Amendments to approved drawings
ref: 2020/4606/P

OAKLEY SQUARE, NW1

REVISED PROPOSED SECTION B-B &
ELEVATION 6

SCALE	JOB NUMBER	DRAWN BY	CHECKED
1:200 @A3	2106	SC	SC
DRAWING NO	DATE	REV	
2115-PL-118	13.06.2019	B

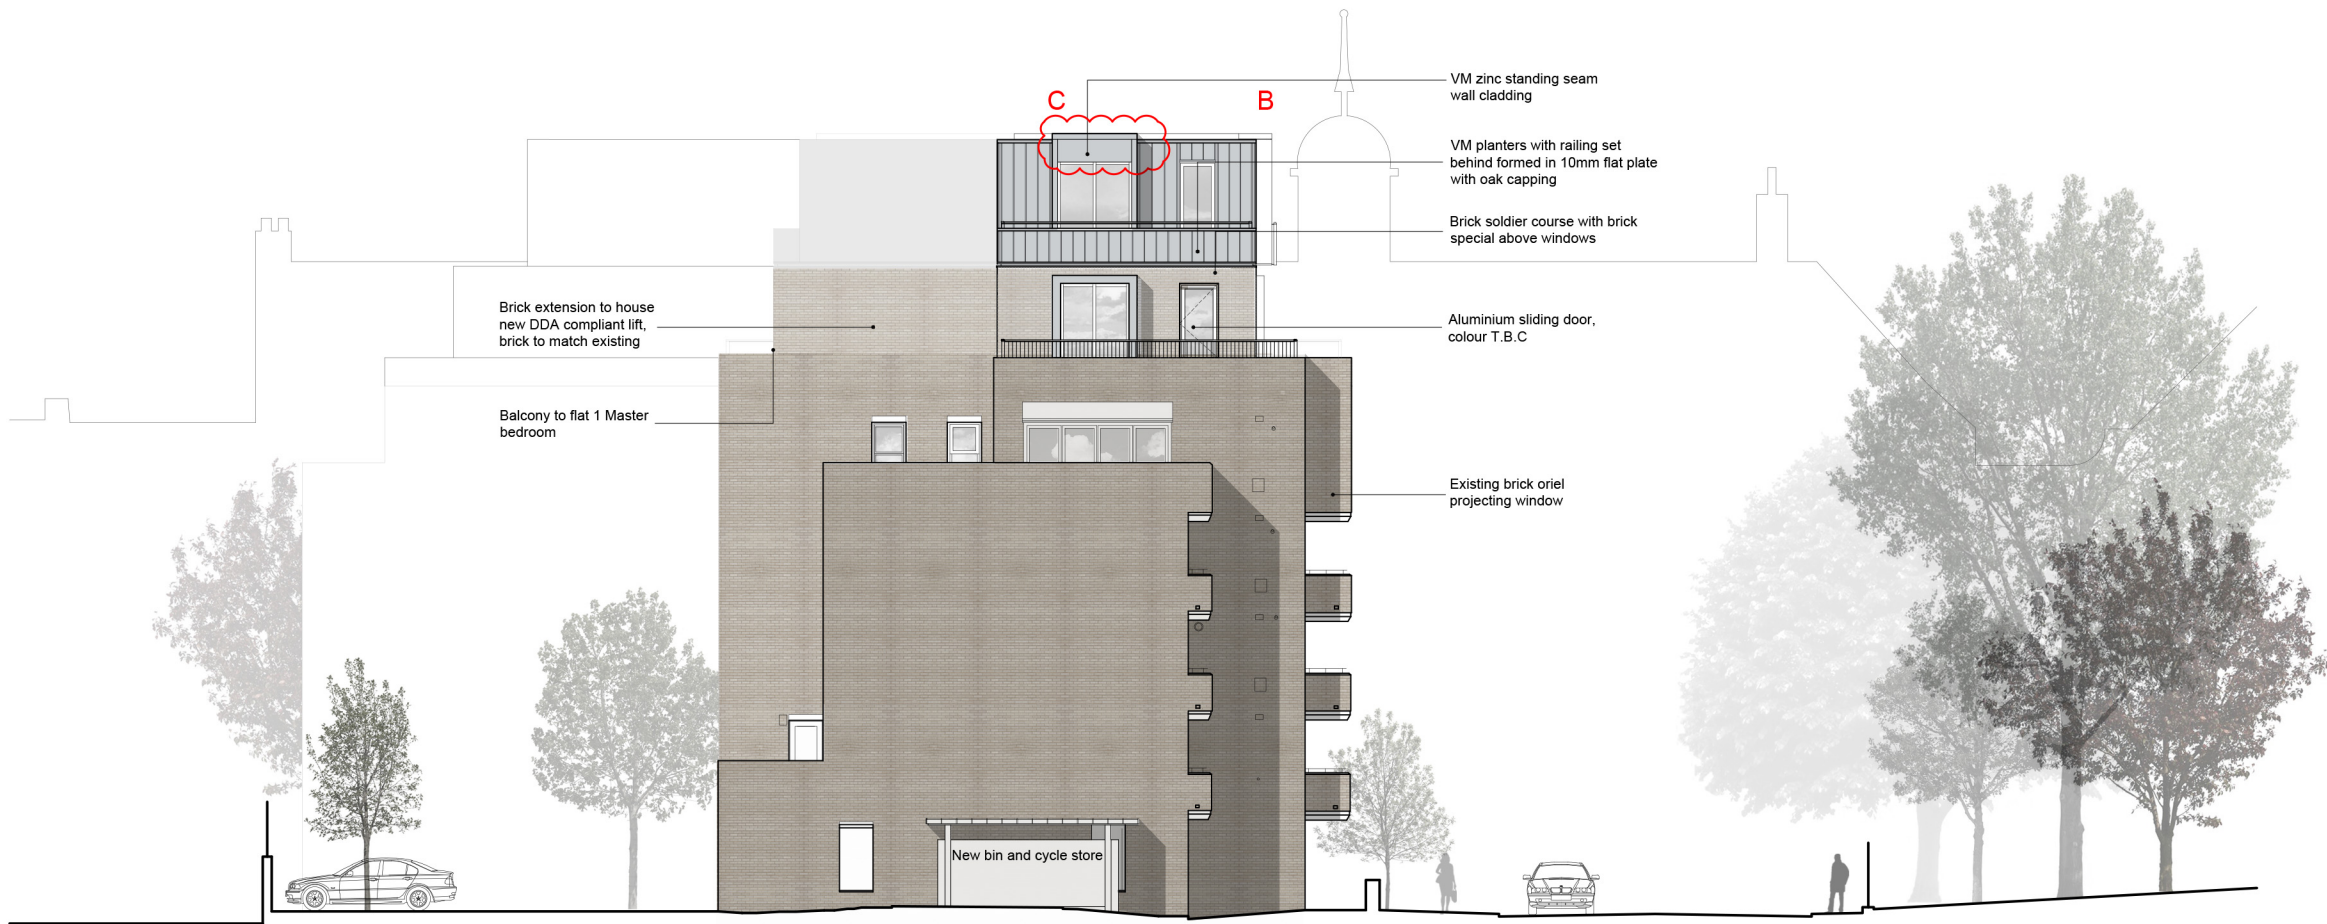
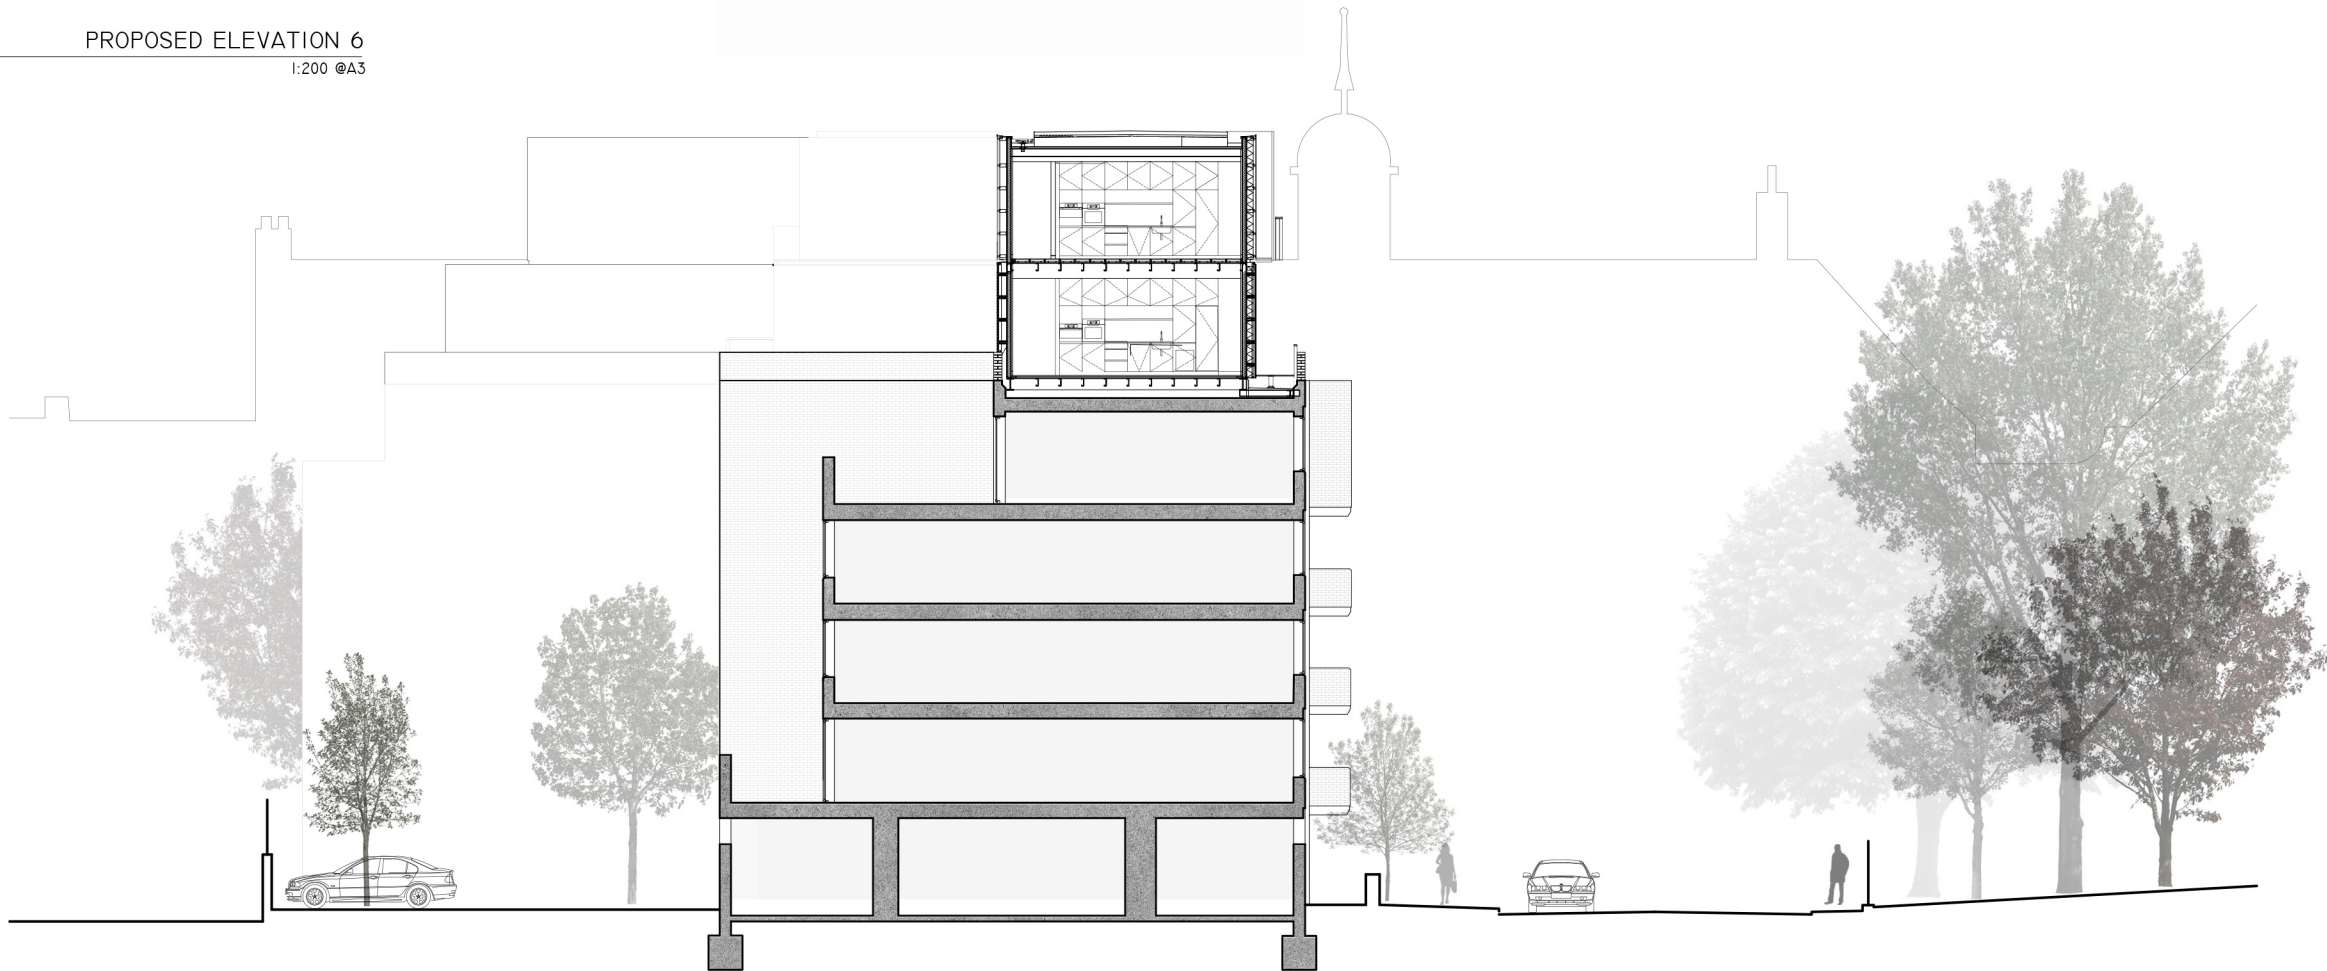
A - Bay window width reduced to a similar size to
other openings balancing elevation

B - Extension height raised by 187mm. Please
note dim between Elevation 1 & 2 changes due
to ground level.

C - Splay panel to the Juliet balcony increased
and window head reduced to align with ceiling
